1	Table 5.3	The area of C2 results to be 7.29 ha (5.10 + 2.19), which is different from 8.07 ha in Table 5.2.While this might not change the outcome of the study, it is recommended to check the values reported in this table.	Response The areas for Catchment C2 have been incorrectly transposed from excel to word. We apologise for this error. The XPstorm modelling has been reviewed and the model has been based on 5.652 ha and 2.422 ha = 8.074 ha This error can be easily corrected with an amendment to Table 5.3. <table><caption>Table 5.3 Developed Case – xpstorm Catchment Details</caption><tr><th colspan="2" rowspan="2">Catchment ID</th><th colspan="2">Impervious Area</th><th colspan="2">Pervious Area</th></tr><tr><th>Area (ha)</th><th>Slope (%)</th><th>Area (ha)</th><th>Slope (%)</th></tr><tr><td rowspan="2">External</td><td>Ext A(1)</td><td>1.59</td><td>0.50</td><td>5.85</td><td>0.25</td></tr><tr><td>Ext C(1)</td><td>0.63</td><td>0.21</td><td>6.72</td><td>0.21</td></tr><tr><td rowspan="6">Internal (Developable Area)</td><td>A</td><td>0.21</td><td>0.50</td><td>0.09</td><td>0.50</td></tr><tr><td>B</td><td>12.27</td><td>0.50</td><td>5.26</td><td>0.50</td></tr><tr><td>B(Road Access)</td

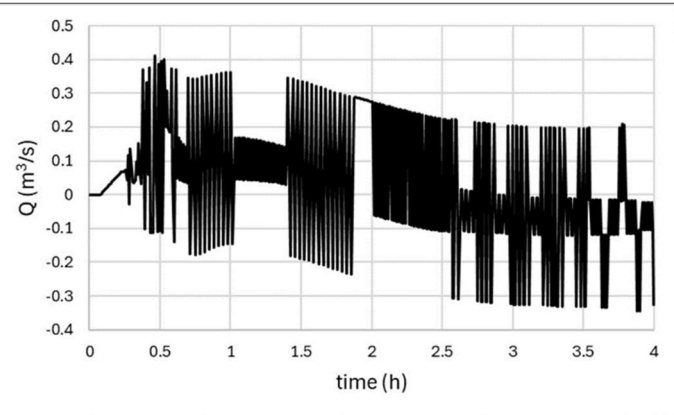
C2 imp = 5.652, per 2.422 ha	-	-	0.51	0.23																																																																												
Internal (remainder of site area)	B3	-	-	0.77	0.31																																																																												
	C3	-	-	11.04	0.40																																																																												
	D	-	-	0.58	0.50																																																																												
	E	-	-	2.61	0.37																																																																												
	F	-	-	0.62	0.23																																																																												
2	Table 5.6	The percentage difference between the two models does not seem correct. The flow value for B3 calculated with the rational method might not be correct. It is recommended to check all the values reported in this table	The peak discharge for Catchment C3 has been incorrectly entered into the table. We apologise for this error. The XPstorm modelling has been reviewed and the model produces an expected peak discharge of 0.22 m³/s for this catchment. This error can be easily corrected with an amendment to Table 5.6. <table><caption>Table 5.6 Developed Case – Peak Flow Validation xpstorm vs Rational</caption><tr><th colspan="2">Catchment/Point of Discharge</th><th>xpstorm (m³/s)</th><th>Rational (m³/s)</th><th>Difference (%)</th></tr><tr><td rowspan="2">External</td><td>Ext A(1)</td><td>1.68</td><td>1.45</td><td>14.3</td></tr><tr><td>Ext C(1)</td><td>1.00</td><td>1.24</td><td>-19.8</td></tr><tr><td rowspan="11">Internal</td><td>A</td><td>0.22</td><td>0.20</td><td>8.9</td></tr><tr><td>B</td><td>12.19</td><td>10.42</td><td>14.5</td></tr><tr><td>B(Access Road)</td><td>0.10</td><td>0.09</td><td>11.5</td></tr><tr><td>B2</td><td>0.12</td><td>0.11</td><td>5.1</td></tr><tr><td>B3</td><td>0.22</td><td>0.19</td><td>13.6</td></tr><tr><td>C1</td><td>0.30</td><td>0.25</td><td>18.1</td></tr><tr><td>C2</td><td>5.64</td><td>5.13</td><td>9.1</td></tr><tr><td>C3</td><td>1.66</td><td>1.49</td><td>10.2</td></tr><tr><td>D</td><td>0.12</td><td>0.11</td><td>5.1</td></tr><tr><td>E</td><td>0.46</td><td>0.41</td><td>11.1</td></tr><tr><td>F</td><td>0.12</td><td>0.11</td><td>8.3</td></tr></table>	Catchment/Point of Discharge		xpstorm (m³/s)	Rational (m³/s)	Difference (%)	External	Ext A(1)	1.68	1.45	14.3	Ext C(1)	1.00	1.24	-19.8	Internal	A	0.22	0.20	8.9	B	12.19	10.42	14.5	B(Access Road)	0.10	0.09	11.5	B2	0.12	0.11	5.1	B3	0.22	0.19	13.6	C1	0.30	0.25	18.1	C2	5.64	5.13	9.1	C3	1.66	1.49	10.2	D	0.12	0.11	5.1	E	0.46	0.41	11.1	F	0.12	0.11	8.3
